2220057

## **SECTION 4.55(1A) MODIFICATION APPLICATION**

This modification application has been prepared by Ethos Urban on behalf of Lendlease (Millers Point) Pty Ltd, pursuant to section 4.55(1A) of the *Environmental Planning and Assessment Act 1979* (EP&A Act) to modify Development Consent SSD 6965 relating to Building R4B Barangaroo South (the site).

**Figure 1** Proposed ground floor amendments

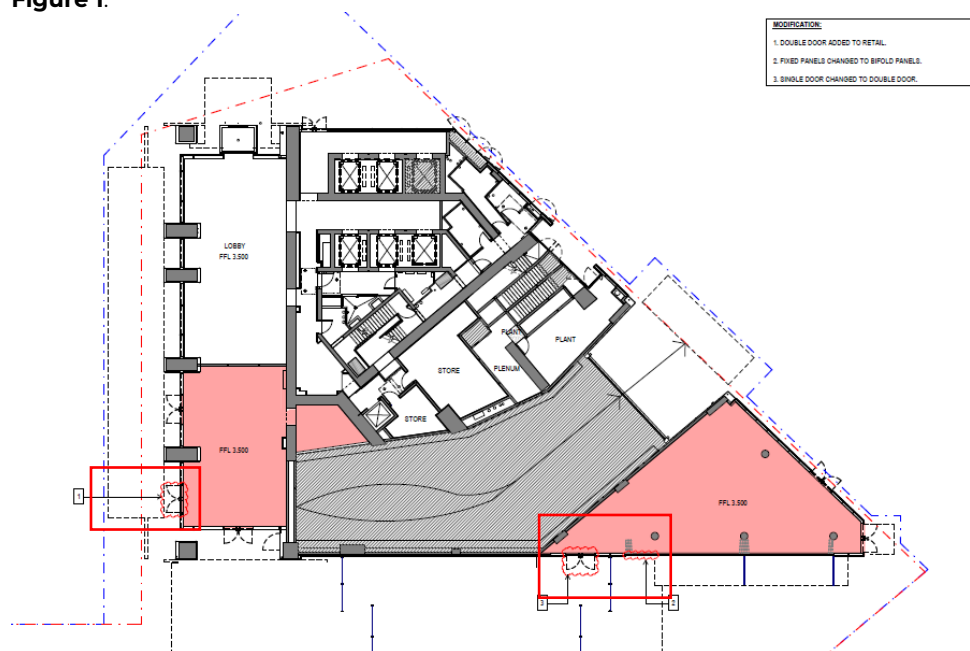
- Refinements to the ground floor façade details and access points, including:
  - Additional double door facing Hickson Park on the ground floor north-eastern frontage.
  - Alteration of a single door to double door on the ground floor eastern frontage.
  - Change of fixed panels to bifold doors on the ground floor eastern frontage.
- Amendments to the Level 02 pool terrace fencing and garden, including:
  - Revised design of the pool fence and gate arrangement.
  - Revised materiality of the terraced garden beds.
  - Replacement of a double door with single door.

Minor changes are proposed to the ground floor retail doors. These changes are proposed to assist with increasing the activation of the ground floor, enhancing public safety and civic amenity. The proposed façade changes are shown in **Figure 1**.

**Figure 2** Proposed terrace amendments

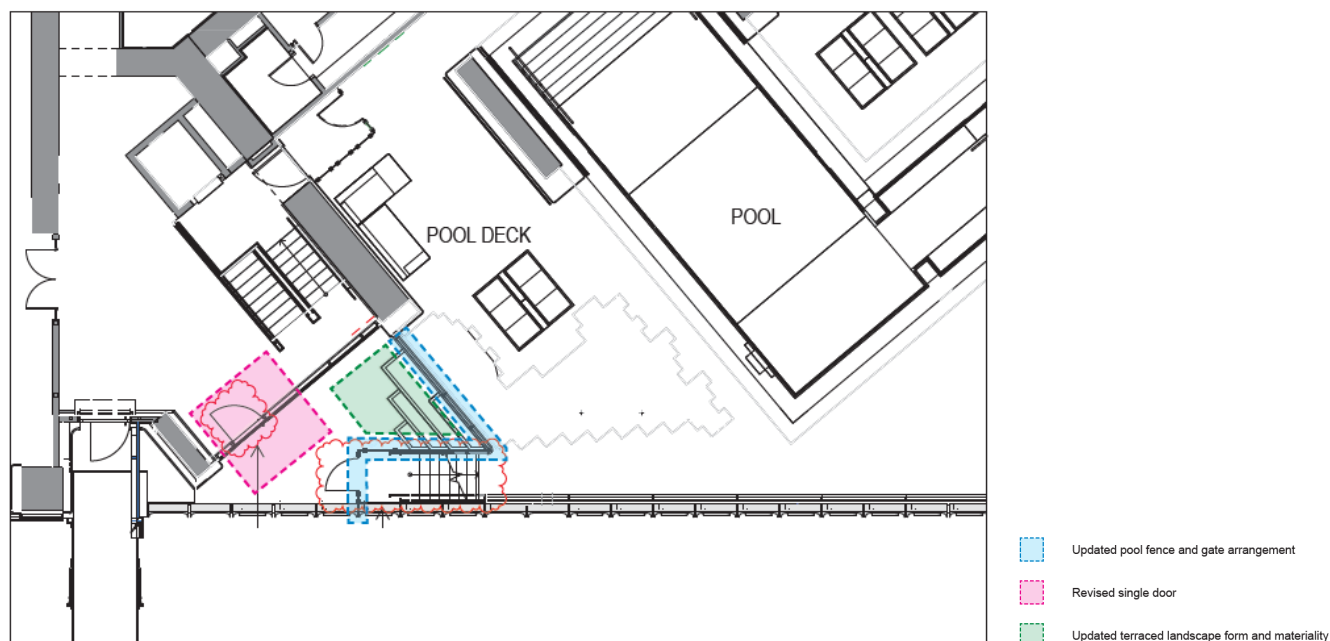
In order to comply with AS 1926.1-2012 'Safety barriers for swimming pools', it was deemed necessary to relocate the swimming pool enclosure gate to the lower external terrace above the Strada. The relocation of the gate has also provided an opportunity to reconsider the materiality of the terraced garden beds, with the approved steel planter boxes proposed to be replaced with concrete blockwork walls faced with the same travertine that is used extensively on the external terraces. The proposed design changes are shown in **Figure 2**.
